NS-TMA-2285

SUBJECT: Responses to Questions on WCAP-9226, "Reactor Core Response to Excessive Secondary Steam Releases"

WCAP-9226 "REACTOR CORE RESPONSE TO EXCESSIVE SECONDARY STEAM RELEASES"
 RESPONSE TO FIRST ROUND QUESTIONS - STATUS SUMMARY

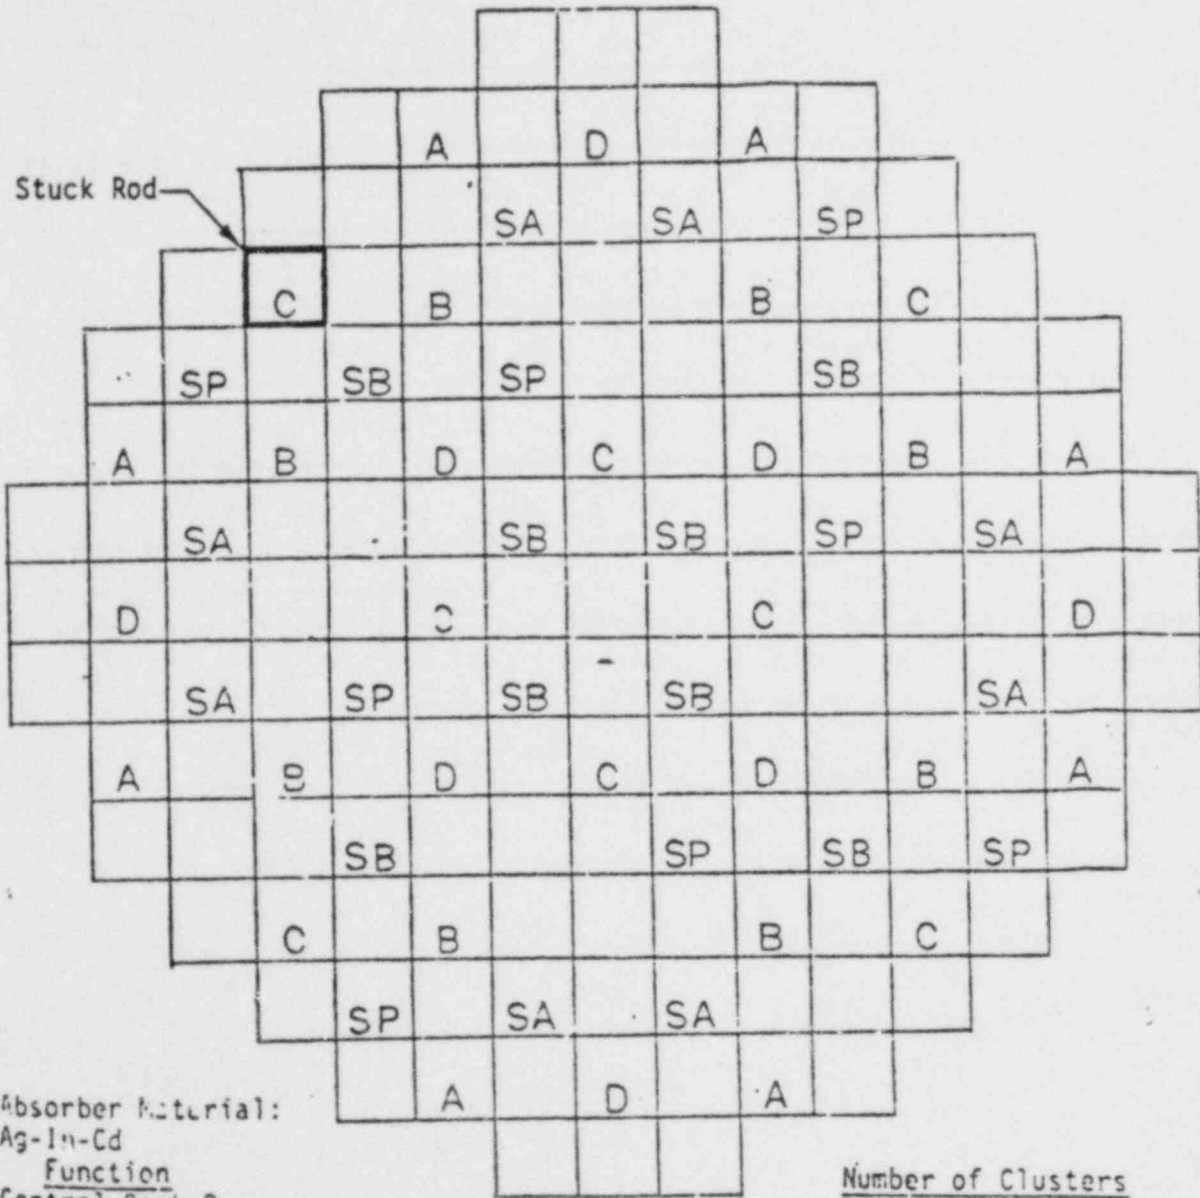
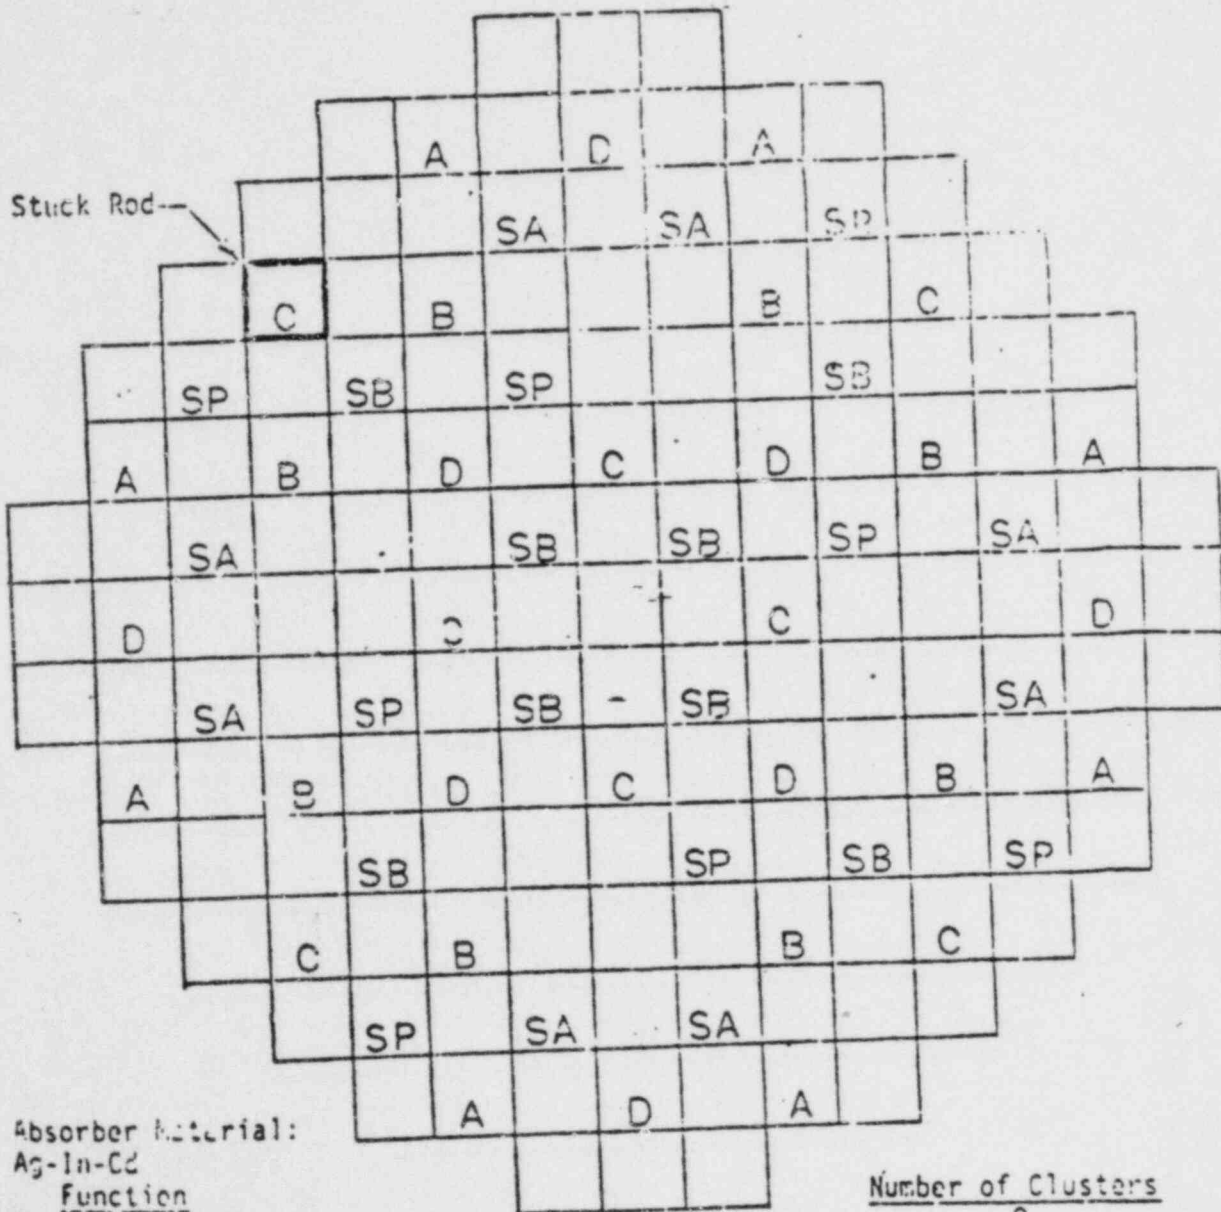
Q) 232.5 Provide representative radial and axial power distributions during the transient.

Attachment 1 is a copy of a request for information pertaining to the Westinghouse steamline break generic analyses performed for WCAP-9226 "Reactor Core Response to Excessive Secondary Steam Releases". Westinghouse considers the attached request as a clarification of WCAP-9226 Round 1 question 232.5 which reads: Provide representative radial and axial power distributions during the transient. The response is provided in Attachment 2, and is identical to the material informally supplied in August, 1979 to S. Salah and R. P. Denise.
